Docket Item #7  
SUBDIVISION #2005-0002

Planning Commission Meeting  
May 3, 2005

**ISSUE:** Consideration of a request for subdivision to divide the subject property into two lots.

**LOCATION:** 227 N. Latham Street

**Tree Save Measures**

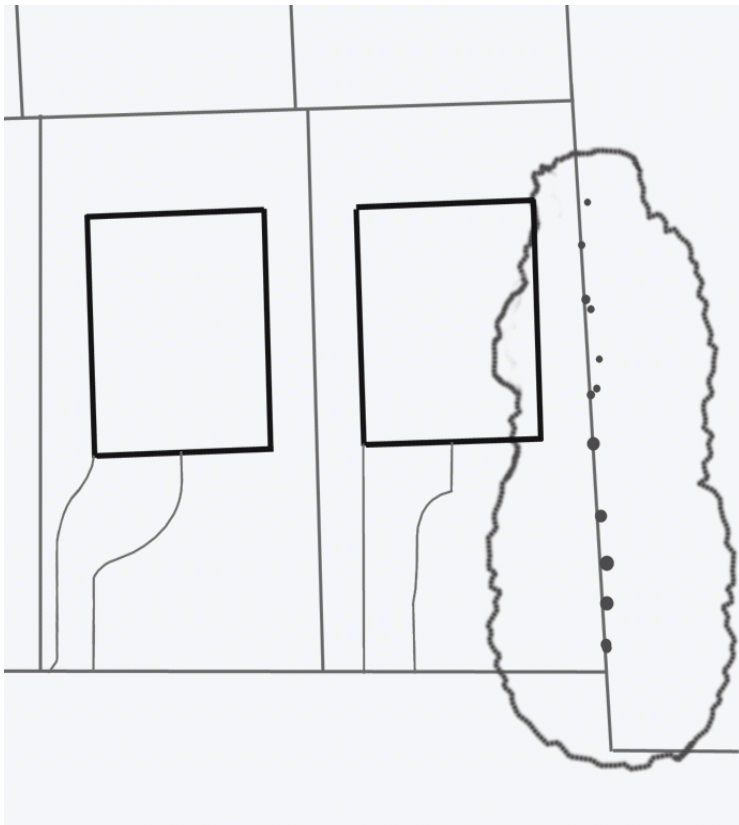
the City Code calls for the Planning Commission to “give due consideration to the preservation and replacement of trees” when reviewing subdivisions. In order to preserve the existing 28" and 30" oak trees that straddle the Latham Street property line, the applicant has agreed not to reconstruct the existing driveway, leaving it in its present condition or limiting improvements to top-coating. Some new driveway will need to be constructed to access the new garage, but the applicant is proposing to shift the house back so that the driveway encroachment into the tree canopy is minimized. Tree protection fencing will be placed around these two street trees, as well as around a 46" maple and a collection of locusts on the park property to the south.

4. Each garage shall be set behind the main facade of the house. (P&Z)
5. In order to preserve the 28" and 30" oaks that are partially located in the Latham Street ROW, the existing driveway shall not be removed, and any new driveway placed within the tree canopy on Lot 500 shall be kept to a minimum, to the satisfaction of the Director of Planning and Zoning. (RP&CA) (P&Z)

7. Tree protection for all on-site and off-site trees to be saved shall be expanded to the maximum extent possible, to the satisfaction of the Director of RP&CA. The maximum limits of disturbance shall be shown on the plat of subdivision and shall be to the satisfaction of the directors of P&Z and RP&CA. (RP&CA) (P&Z)
